Access Compliance Report

Public Rights-of-Way

Intersection ID: 29915	Main Street: NORTHRIDGE_DR	Cross Street: WYNDHAM_HILL_DR	Location: SE
ADA ID: A51E2B77970A	Ramp Type: PerpDiag	Initial Pass/Fail: Fail	Overall Compliance: No
Severity Score: 46.25			
Codes/Mitigation Info/Possible Solution		Field Measurements/Component Compliance

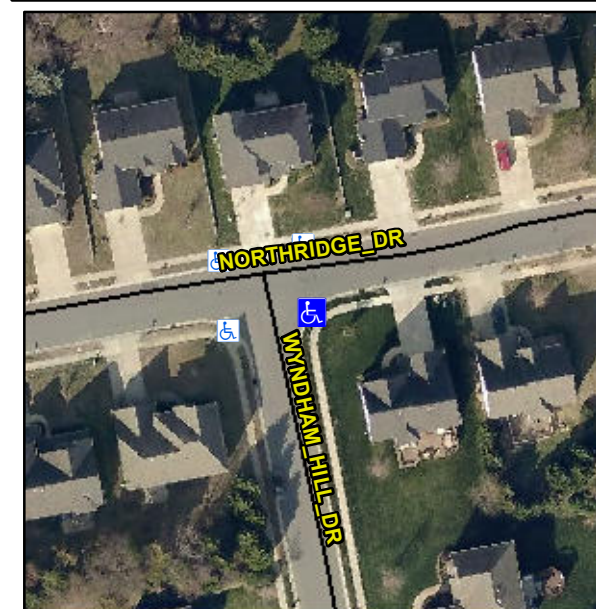
R304.5.1, R304.2.2, R304.5.3

Compliance	Description	Data	Compliance	Description	Data
N/A	Ramp Length (in)	50.0	No	Ramp Slope (%)	10.2
No	Ramp Width (in)	42.0	No	Ramp XSlope (%)	8.8
N/A	Flare Type LT	N/A	N/A	Flare Type RT	N/A
N/A	Flare Slope LT (%)	N/A	N/A	Flare Slope RT (%)	N/A
N/A	Flare Traversable LT?	N/A	N/A	Flare Traversable RT?	N/A
N/A	Landing Length (in)	N/A	N/A	DWS Provided?	N/A
N/A	Landing Width (in)	N/A	N/A	DWS Contrast?	N/A
N/A	Landing Slope (%)	N/A	N/A	DWS Length (in)	N/A
N/A	Landing X Slope (%)	N/A	N/A	DWS Full Width?	N/A
N/A	Landing Curb? (Y/N)	N/A	N/A	DWS Offset (in)	N/A
N/A	Shared Landing?	N/A			
N/A	Gutter Ponding?	N/A	N/A	Gutter Slope (%)	N/A
N/A	Gutter Lip Ht (in)	N/A	N/A	Gutter X Slope (%)	N/A
N/A	Painted X Walk1?	No	N/A	Painted X Walk2?	No
	X Walk 1 Direction	To N		X Walk 2 Direction	To W
N/A	X Walk 1 Width (in)	N/A	N/A	X Walk 2 Width (in)	N/A
	X Walk 1 Slope (%)	1.4		X Walk 2 Slope (%)	4.6
	X Walk 1 X Slope (%)	7.7		X Walk 2 X Slope (%)	3.5

N/A	Ramp inside XWalk1?	N/A	N/A	Ramp inside XWalk2?	N/A
	Road Slope (%)	6.8	N/A	Clear Space?	N/A
	Road X Slope (%)	3.2	N/A	Clear Space to XWalk (in)	N/A
N/A	Any Obstructions?	N/A	N/A	Storm Grate/Utility Hazard?	N/A
	Obstruction Type			Storm Grate/Utility Type	
		N/A			N/A
			Yes	Surface Condition? (G/P)	Good

Remove & Replace Curb Ramp With Two New Directional Ramps or Equivalent.
